DNJ ADDITION TO MOBILE SUBDIVISION

APPLICATION NUMBER 9 DATE December 15, 2016

REQUEST Subdivision

DETAIL SITE PLAN

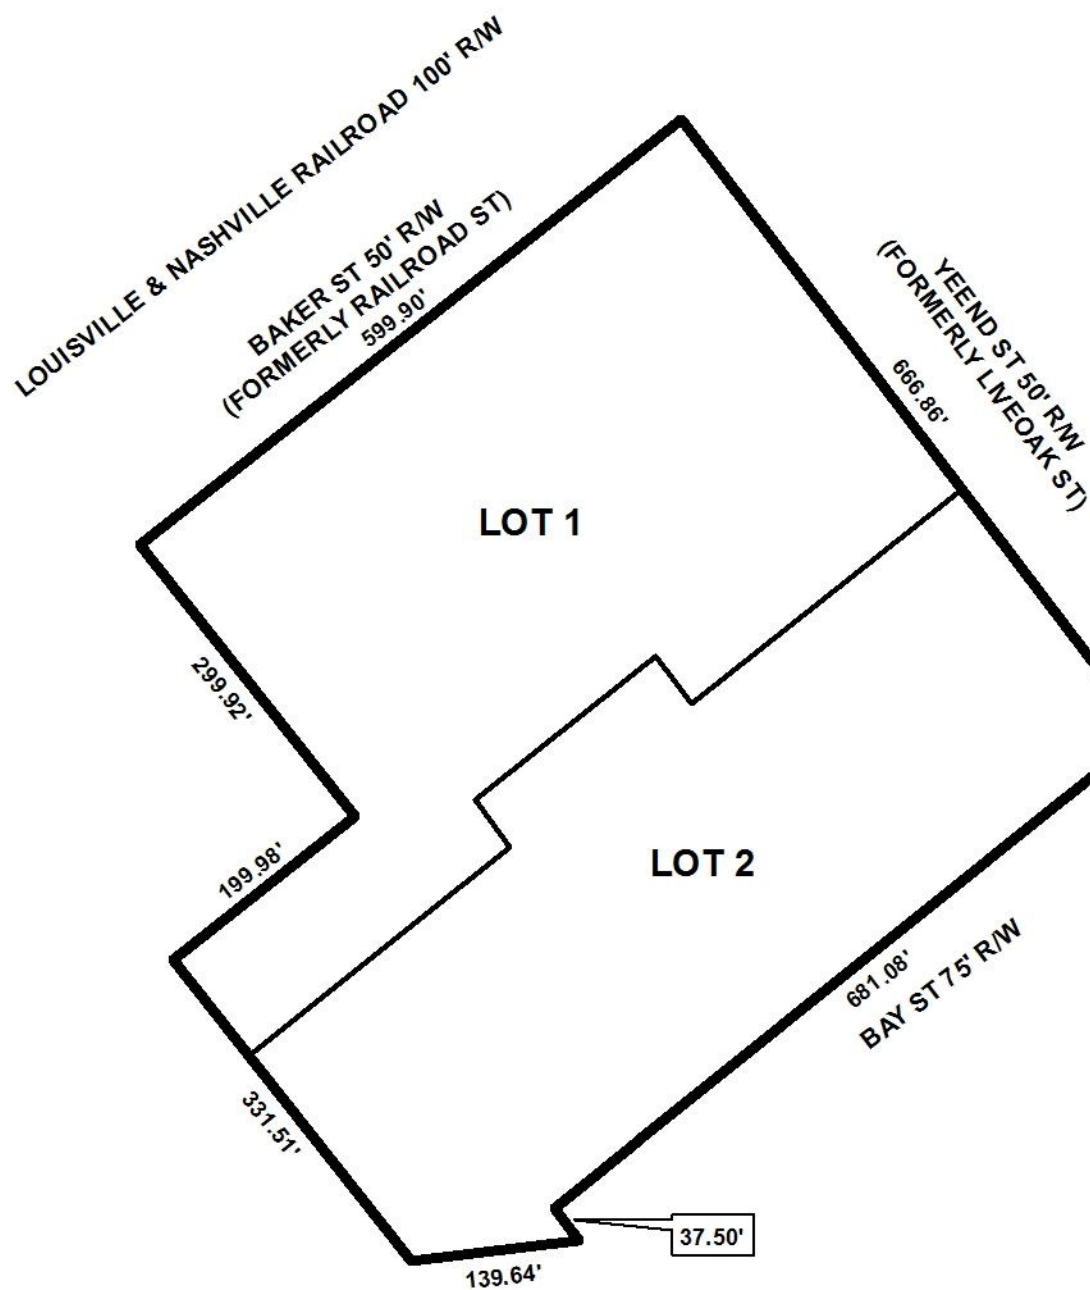
- B. Dedicate the corner radius (25' minimum or as approved by the City Engineer and Traffic Engineer) at the northern corner of LOT 1 (corner of Baker Street and Yeend Street).

- G. The existing drainage ditch that runs through LOT 1 and LOT 2 needs to be contained in a PUBLIC (Dedicated to the City of Mobile) drainage EASEMENT; the width and alignment of the easement shall be coordinated with, and approved by, the City Engineer. Additional width may be required to allow vehicular and equipment access.

plat should also be revised to illustrate the dedication of a 25' corner radius at the intersection of Baker Street and Yeend Street.

The proposed lots meet the minimum size requirement of the Subdivision Regulations. The plat labels each lot with its size in both square feet and acres. However, as corner radius dedication is required for Lot 1, that lot size should be revised to reflect the area after dedication. Each lot should be labeled on the Final Plat with its size in both square feet and acres, after any required frontage dedication or a table should be furnished on the Final Plat providing the same information.

- 1) revision of the plat to illustrate a minimum building setback line of 65' as measured from the centerline of Yeend Street and the proposed Royal Street South major street;

- 2) revision of the plat to illustrate a 25' minimum building setback line along Baker Street as measured from the current right-of-way line;
- 3) revision of the plat to provide a 25' radius corner dedication at the intersection of Baker Street and Yeend Street;

- 5) revision of the plat to label each lot with its size in both square feet and acres, after any required corner radius dedication for Lot 1, or the furnishing of a table on the Final Plat providing the same information;
